STAFF REPORT

Request of **LDG Multifamily LLC (applicant)** for **Joyce Robinson Foundation, Inc. (owner)** for a Zoning Map Amendment from Suburban Residential One (SR-1) to Urban Residential Two (UR-2) for an approximate 19 acre area located at 10637 Dixie Highway, Boone County, Kentucky. The request is for a zone change to allow for the development of a 312 unit multi-family residential development with on-site amenities and a Variance increasing the height of a fence along the rear property line from six (6) feet to eight (8) feet.

ZONE CHANGE/CONCEPT PLAN COMMITTEE REPORT

CONCEPT PLAN LDG WALTON APARTMENTS 10637 DIXIE HIGHWAY BOONE COUNTY, KENTUCKY

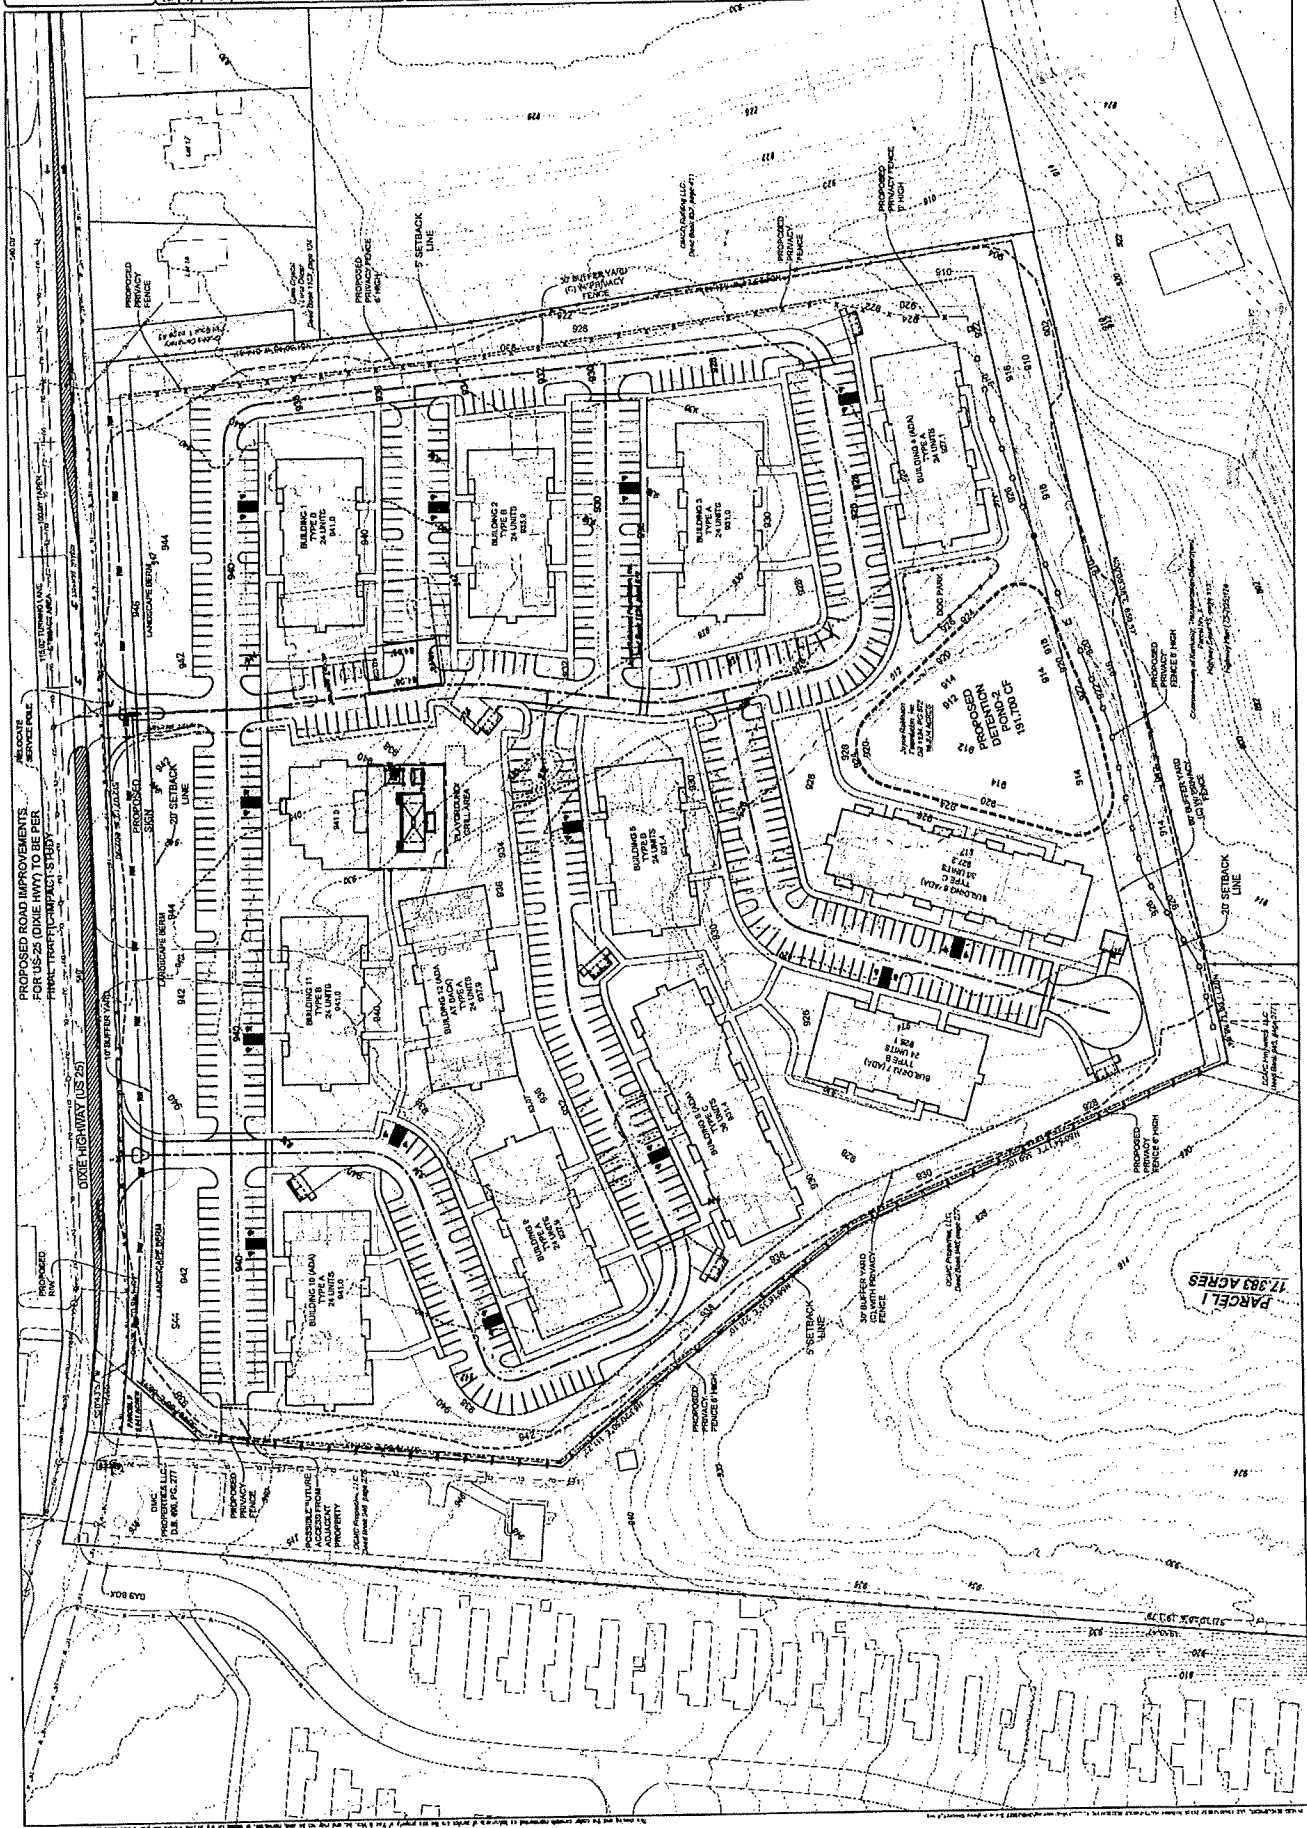
The submitted plan indicates that the proposed six (6) foot high privacy fence will extend into the front yard along the north and south property lines.

The submitted plan indicates that the proposed fence along the north and a portion of the south property lines will be located along the property line and not within the center of the proposed buffer yard.

While the applicant has provided such access, the plan also shows a six (6) foot high privacy fence that would block such access.

1. Development shall be consistent with the revised Concept Development Plan presented at the September 18, 2024 Zone Change Committee meeting.
2. Development shall meet the minimum requirements of the zoning regulations, except for the height of the fence along the rear property line, as modified by the approved Variance.

5. The access to the property to the north of the site in question, for residential and non-commercial traffic, may be eliminated only if alternative access is provided to that property.
